**Request for Bid
Phase 1 Sewer Rehab Group 2 CIPP Addendum No. 3 to
RFB No. 197640.71.0390
November 23, 2021**

**Section 2
Updates to Technical Specifications**

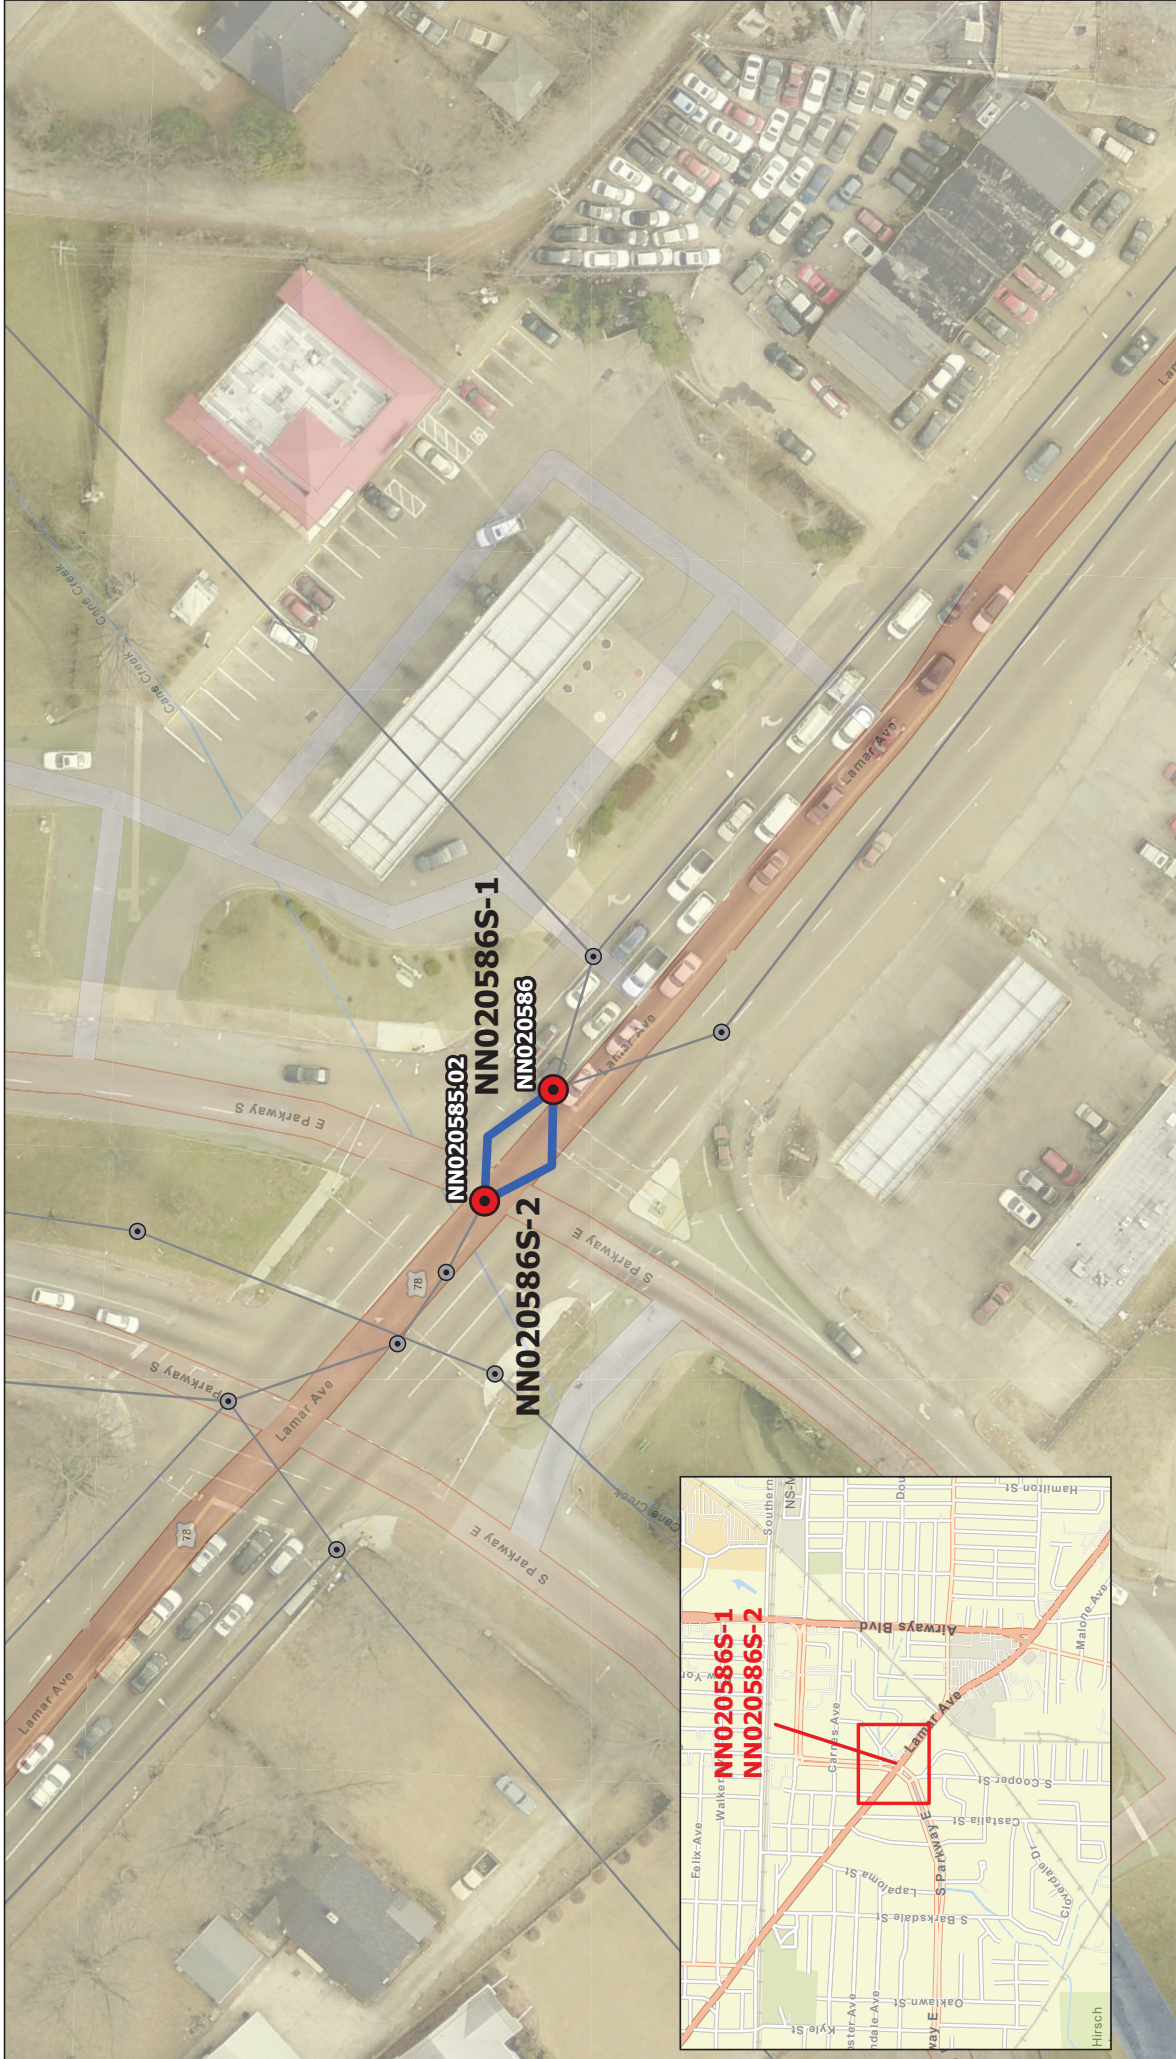
- Gravity Mains (To be CIPP'ed)
- Access Manholes
- Gravity Mains
- Manholes
